Appl. No. 10/821,361  
Amdt. Dated April 12, 2006  
Reply to Office action of December 15, 2005

**Amendments to the Drawings:**

FIG. 2

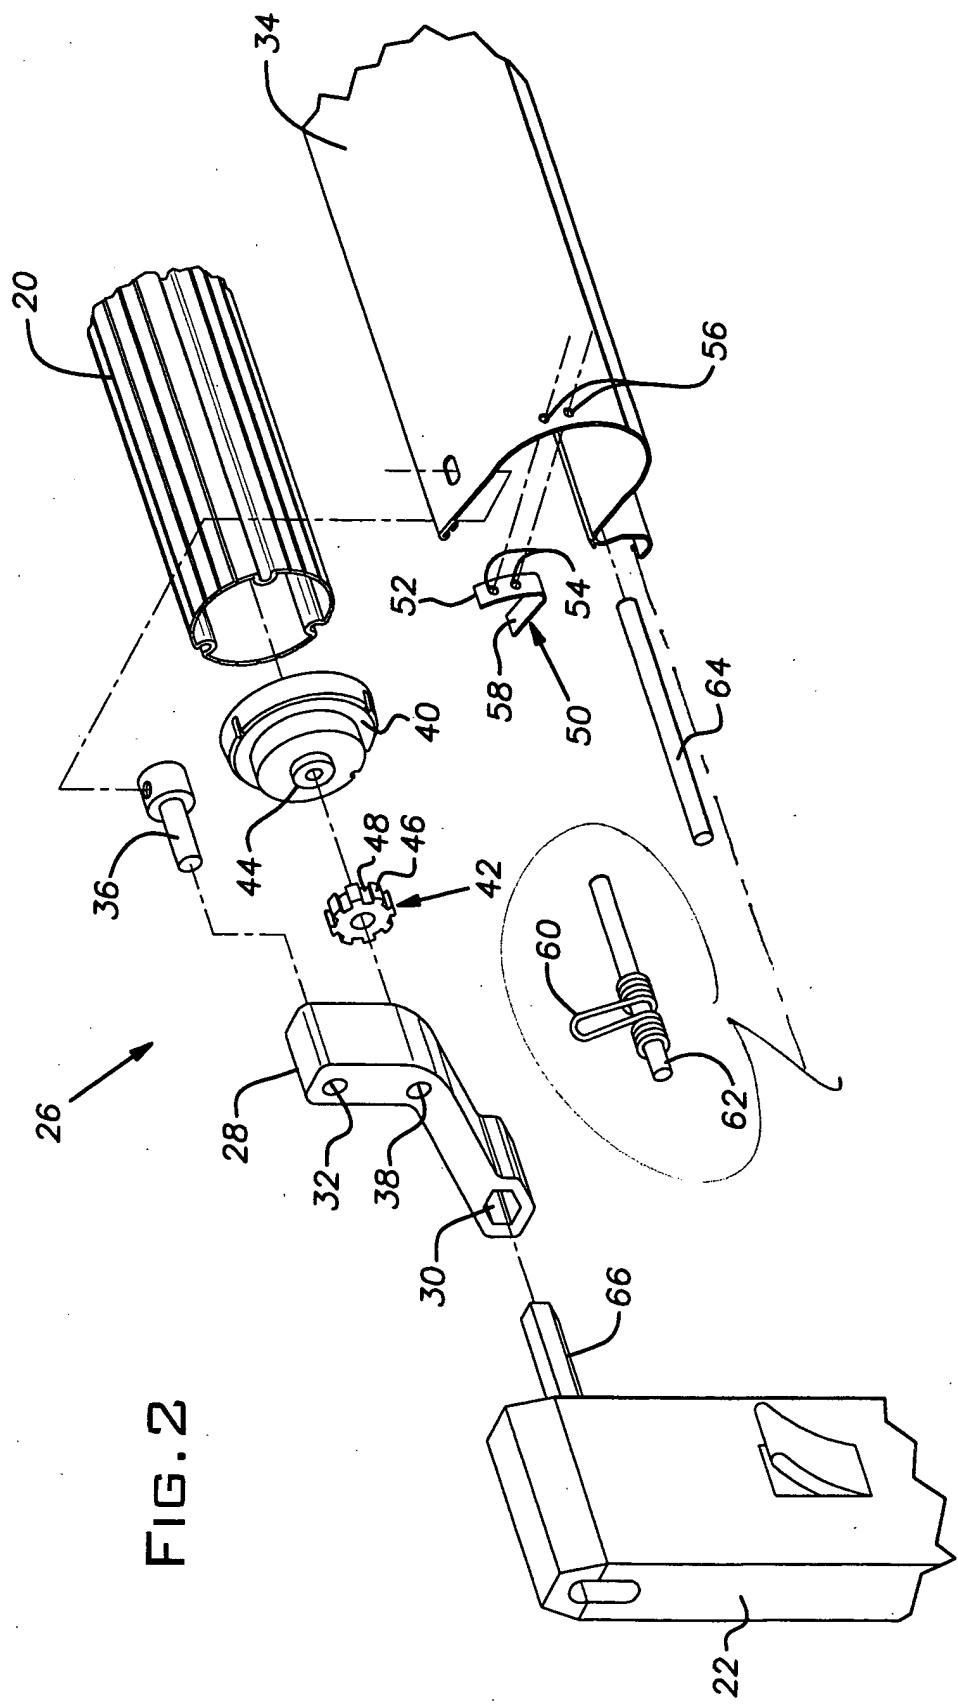
The drawings are objected to because in Fig. 2, spring and shaft 62 are not shown as being attached to the other elements. Fig. 2 has been amended herein. Accordingly, withdrawal of this objection is requested.

The attached sheet of drawings includes changes to Fig. 2. This sheet replaces the original sheet including Fig. 2. In Fig. 2, spring 60 and shaft 62 have been amended to show their attachment to weather shield 34.
